STAFF REPORT

SUBJECT: FP-2020-0007
Sky Mesa Highlands No. 1

Final plat consisting of 82 buildable lots and 13 common lots on 32.92 acres of land in the R-4 zoning district.

Redevelopment Plan for Lot 28, Block 1:

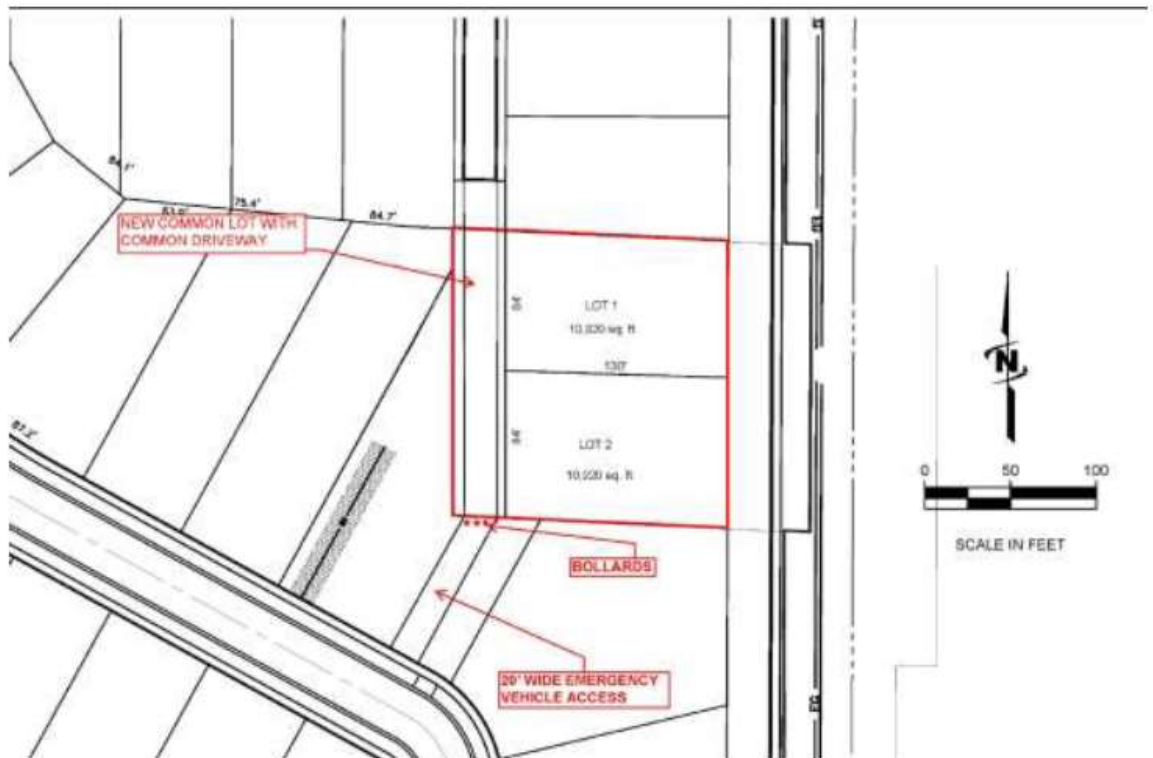
- d. Depict a 20' wide driveway along the east side of Lot 29, Block 1 stubbing to the out-parcel to the north (i.e. Lot 28, Block 1) for future emergency access with redevelopment of the out-parcel in accord with the concept plan approved with the preliminary plat. The driveway shall be constructed in the future when Lot 28, Block 1 redevelops and shall be constructed to accommodate an imposed load of 80,000 GVW as set forth in International Fire Code Section 503.2.1 and D103.6.1 and D103.6.2.

B. Final Plat (dated: 10/14/20)

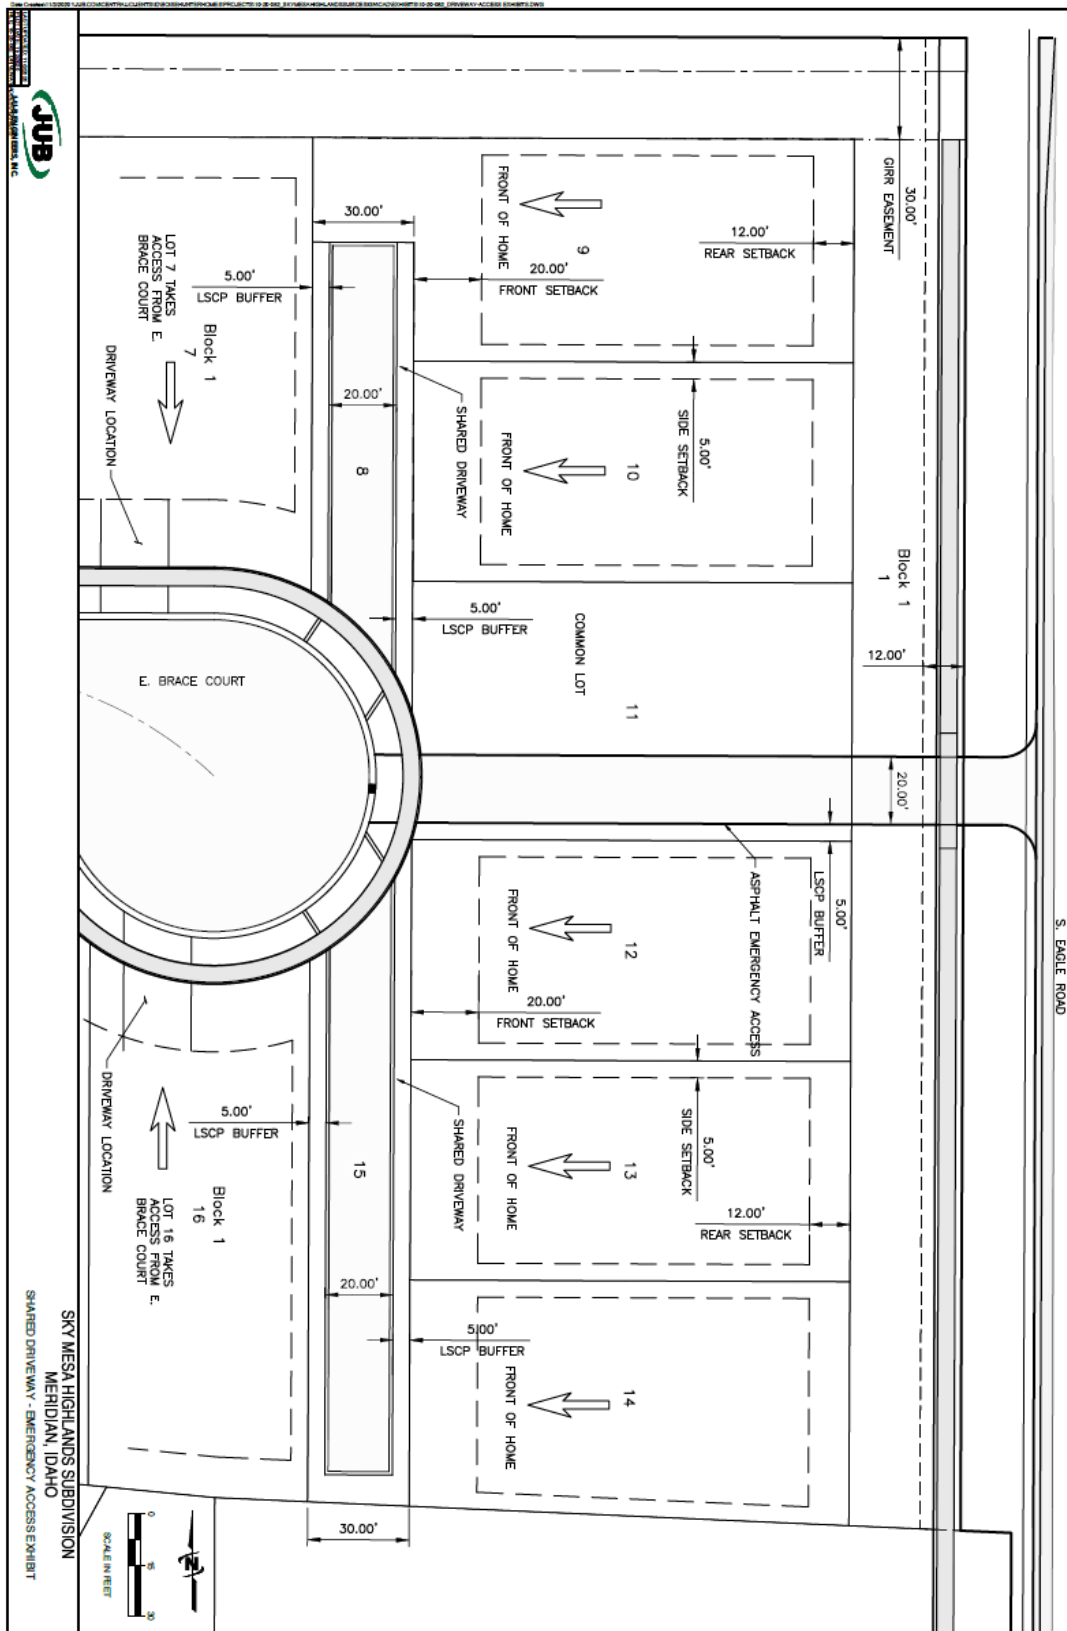
- a. A scenic easement shall be depicted on Lots 15-27, Block 3 for homes to be five feet (5') below the ground elevation of Mr. Cantrell's (#R1835500400) and neighboring homes adjacent to the southern boundary of the site on Lake Hazel Rd. *A copy of the easement shall be submitted to the Planning Division prior to signature on the final plat by the City Engineer.*

- b. Include a note stating the existing driveway access for Lot 28, Block 1 via S. Eagle Rd. is allowed to remain until the property redevelops in the future. At such time, access shall be taken internally from within the subdivision via the common driveway on Lot 15, Block 1.

- c. Note #2: Exclude Lots 7 and 16, Block 1 as these lots will be accessed via the public street, not the common driveway.
 - d. Note #5: "Lots shall not be reduced in size without prior approval from the health authority and the City of Meridian."

- e. Note #11: Include the recorded instrument number of the ACHD License Agreement.
 - f. Note #14: Include the recorded instrument number of the Development Agreements (#2017-119308 Sky Mesa; #2020-099420 Sky Mesa Highlands).

- g. Note #15: ". . . has direct lot or parcel access to Eagle Road until such time as the property redevelops. At such time, sole access shall be taken from the common driveway on Lot 15, Block 1 and direct access via Eagle Road shall be prohibited."

- h. Easement Note #2: Exclude Lots 7 and 16, Block 1 as these lots will be accessed via the public street, not the common driveway.
 - i. Easement Note #5: Include the recorded instrument number of the Bureau of Reclamation Easement.

- j. Easement Note #6: Include the recorded instrument number of the existing ACHD sidewalk easements.
 - k. Depict a permanent easement on Lot 29, Block 1 for a 20-foot wide emergency access driveway to Lot 28, Block 1 consistent with the concept plan in Section V.B, to be constructed upon redevelopment of Lot 28, Block 1.

D. Common Driveway Exhibit

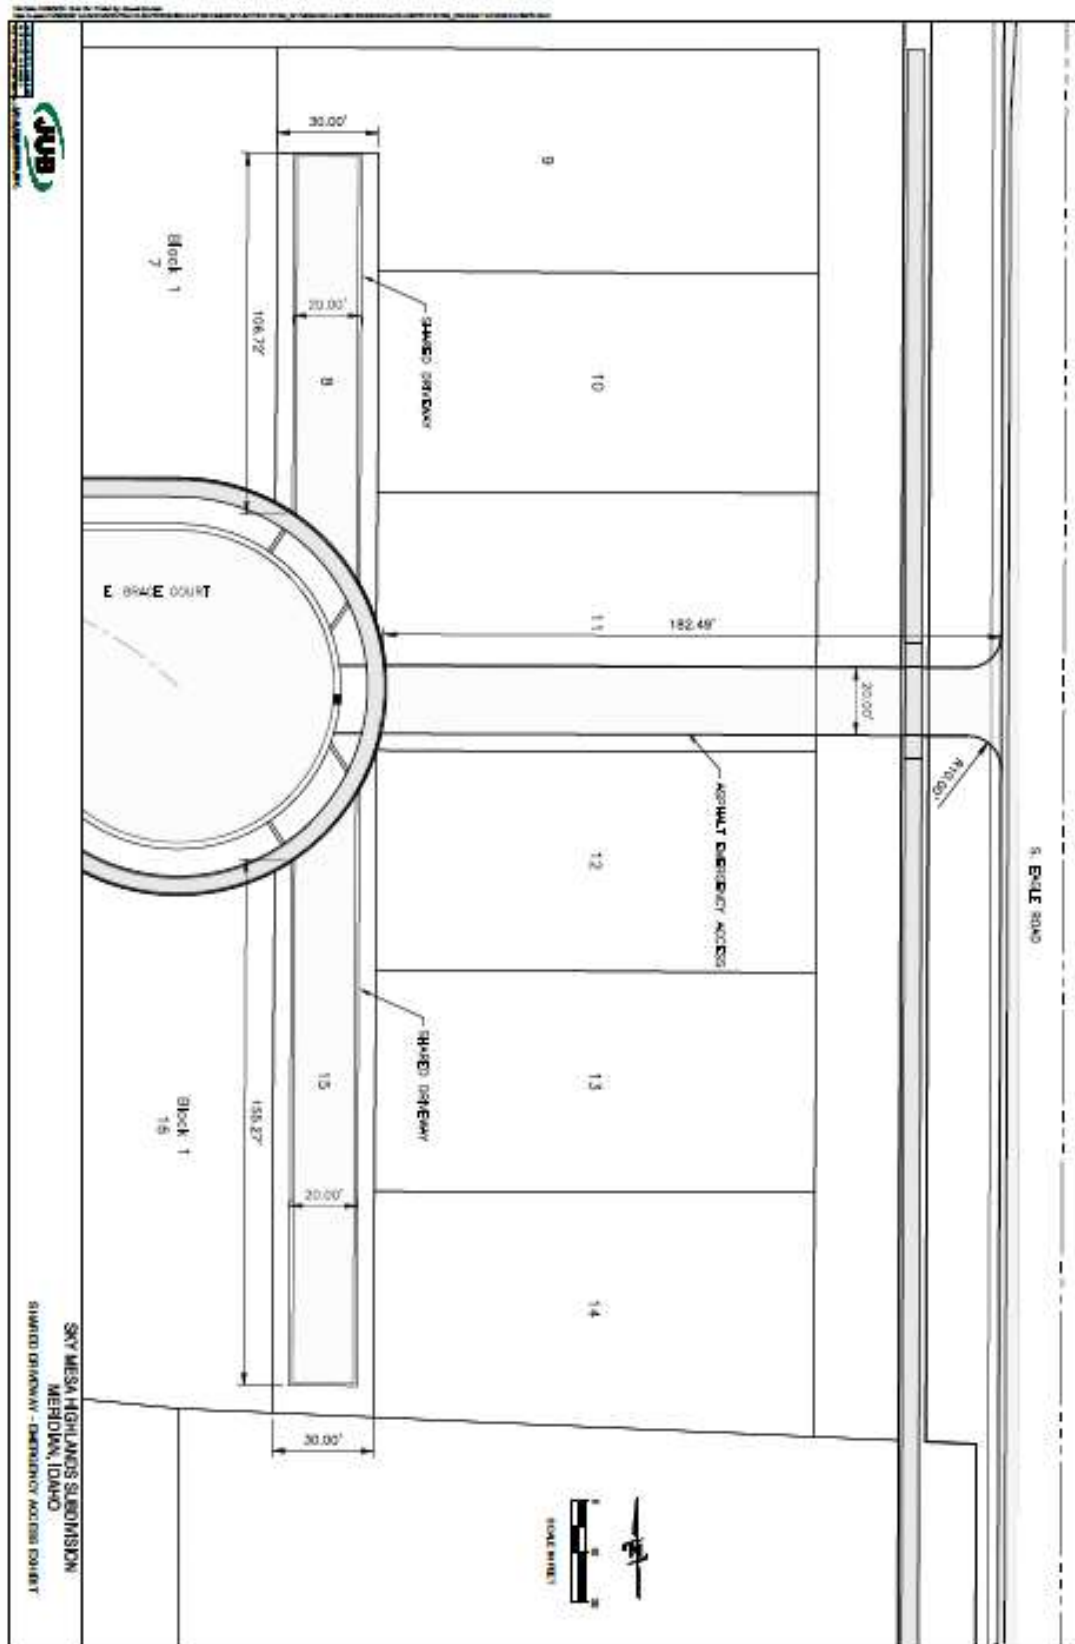
6. Construction of the common driveways on Lots 8 and 15, Block 1 shall comply with the standards listed in UDC 11-6C-3D and with the exhibit in Section V.D.
